RETI Phase 2B Report

**Presentation of Final Phase 2B Report For
Consideration**

RETI Stakeholder Steering Committee

May 3, 2010

Updated Bubble Chart

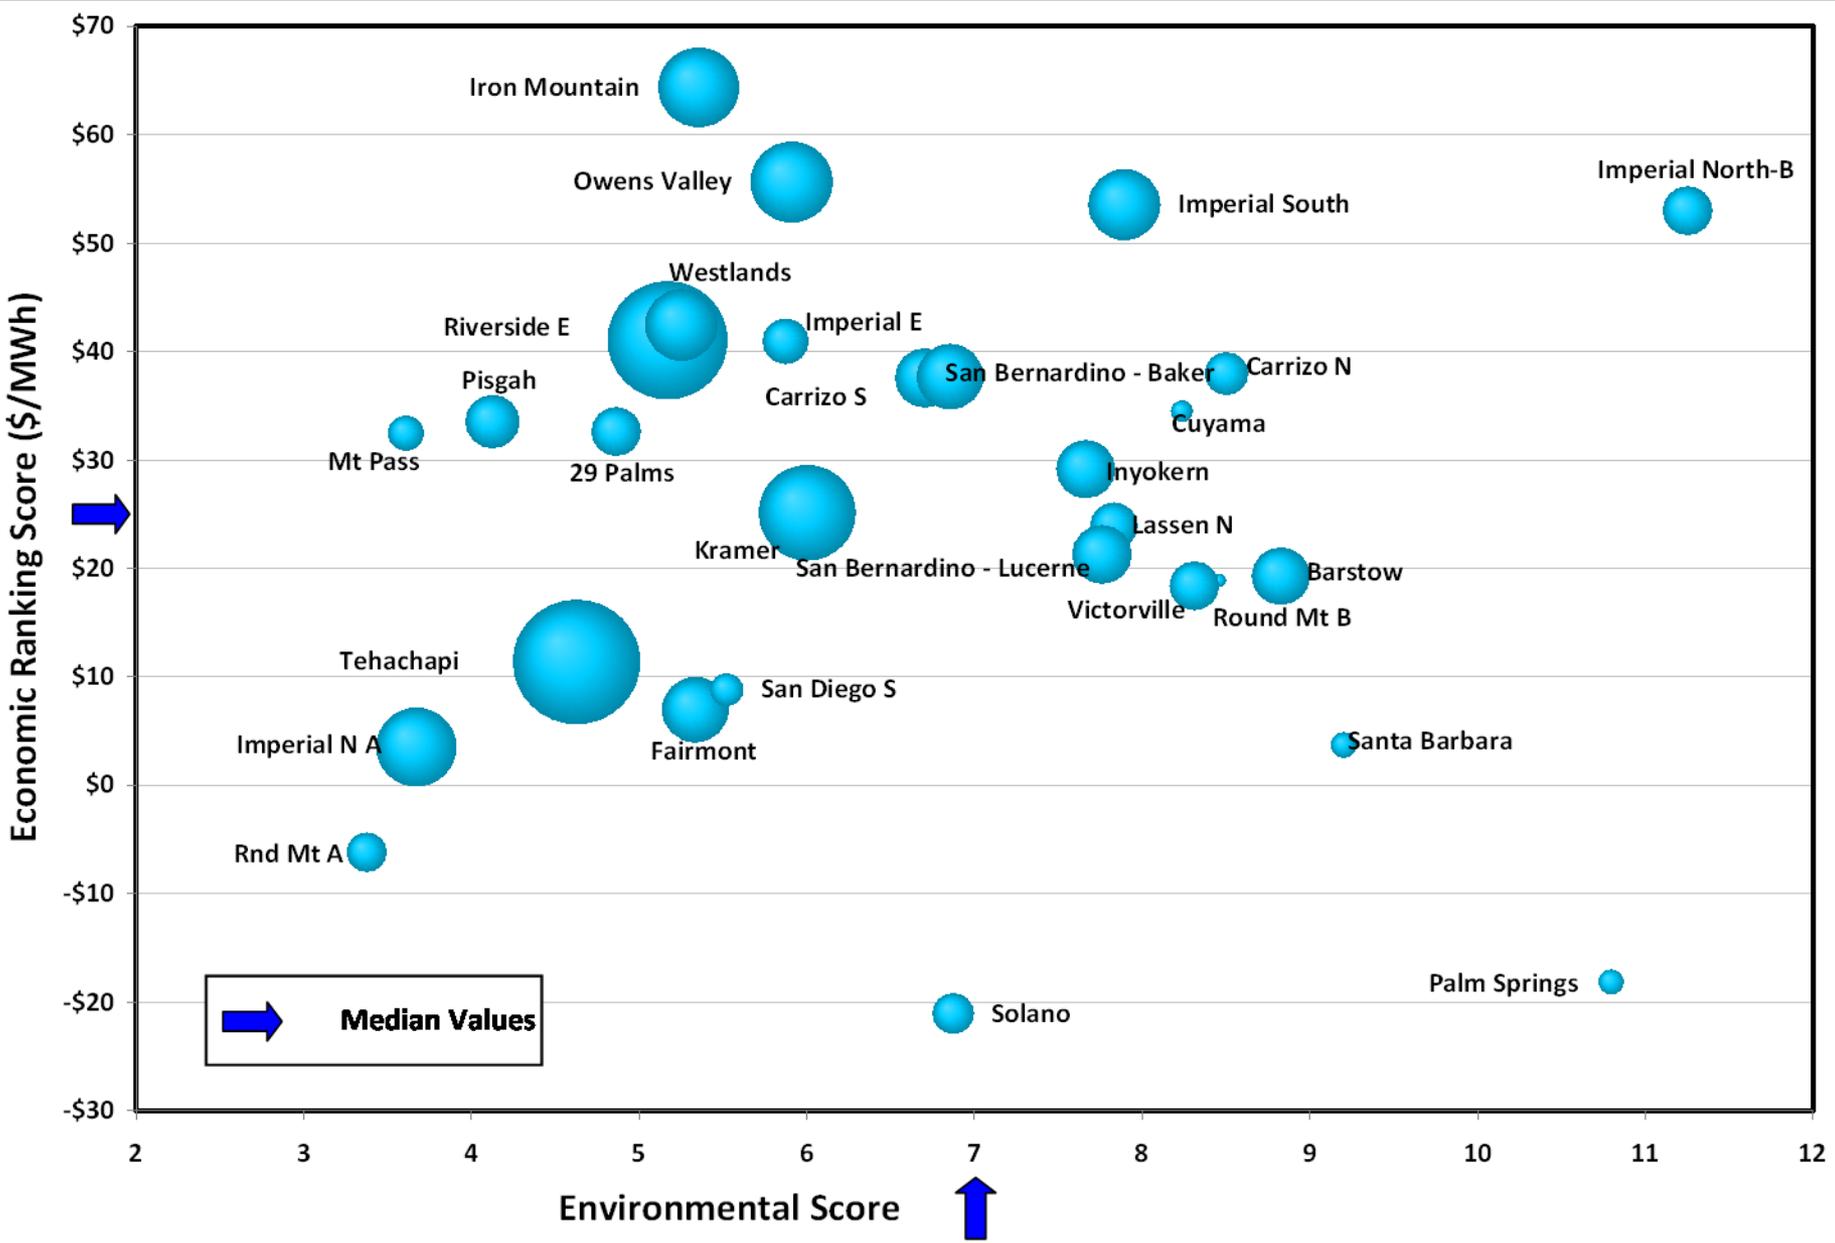
- Westlands and Inyo (Owens Valley) CREZs inappropriately added
- Uncertainty bands look smaller
- Include Renewable Energy Transmission Planning Process in Section 2.3
- Differences in transmission costs should be explained
- Add OOS transmission cost table
- Fix inconsistency in rank cost threshold for competitiveness (\$10-15/MWh)
- Clarify tax credit sensitivity
- Note that EWG scores not consensus based. Add bubble chart with wind industry formulas
